Moody Nolan

Addendum

Project	The Falls on Refugee Road	**Addendum Number**	1
Project Number	23446	**Date**	06/11/2025
To	All Bidders

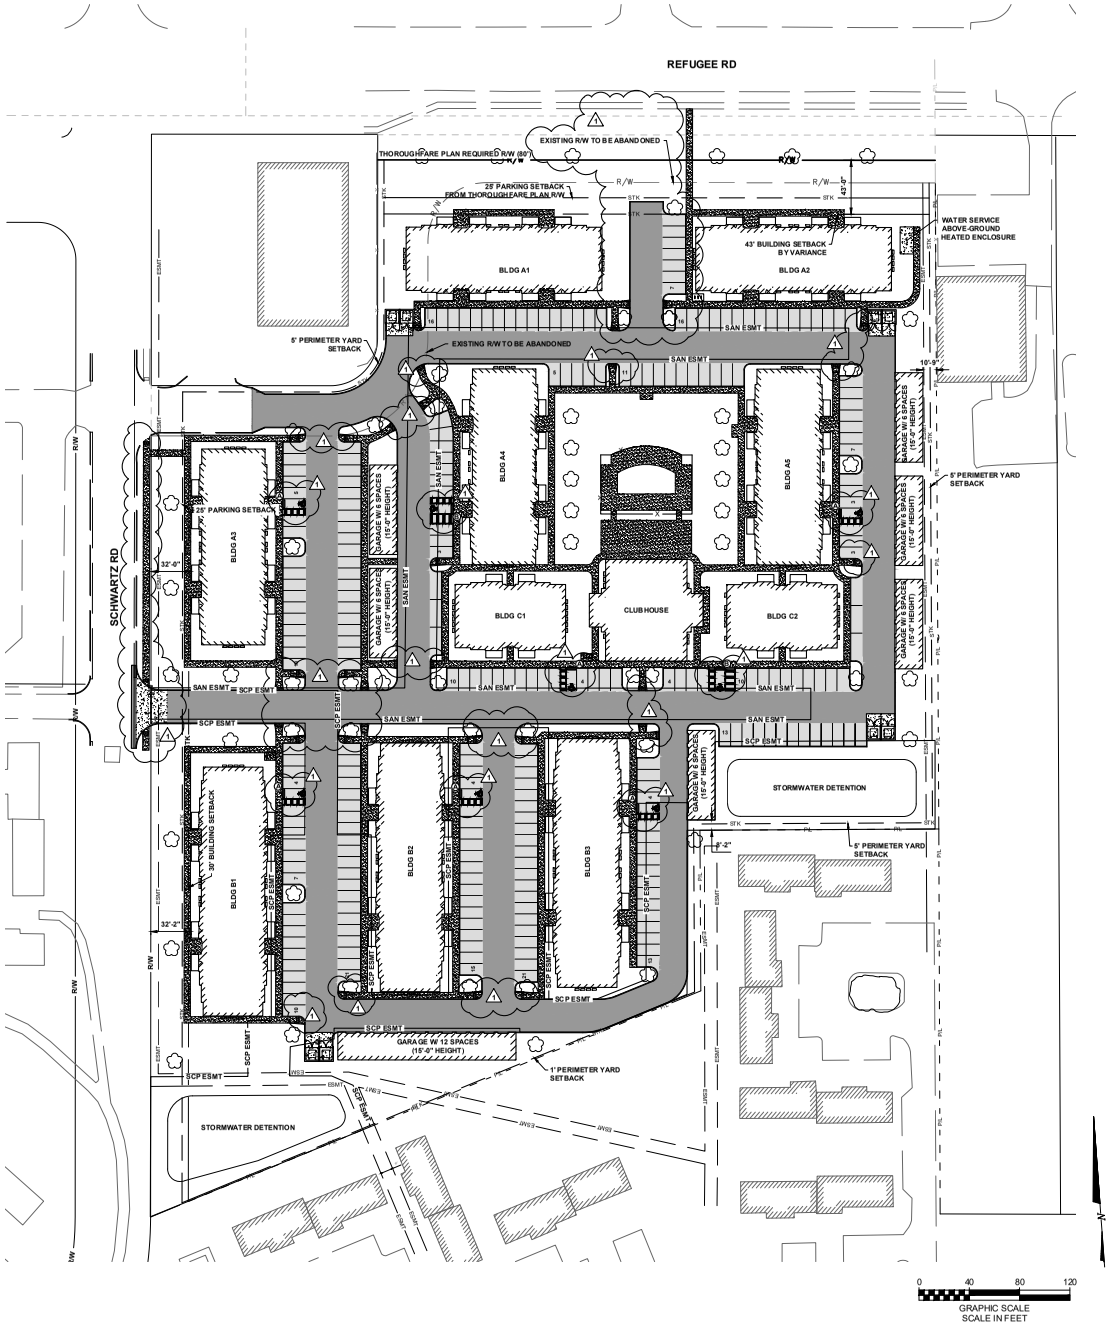
1. SHEET C101 – OVERALL STAKING PLAN
    A. **REMOVE** Refugee Road fire access drive.
    B. **REVISE** building footprints.
    C. **REMOVE** sidewalk east of building A1.
    D. **REVISE** dumpster concrete pad locations.
    E. **ADD** sanitary easement.
    F. **REVISE** Schwartz Road drive pavement to concrete and curb and gutter.
    G. **ADD** detectable warning to all curb ramps.
    H. **REVISE** sidewalk for benches in courtyard.
    I. **REVISE** storm easement.
    J. **ADD** ADA parking signs.
    K. **ADD** sidewalk along east side of Schwartz Road.
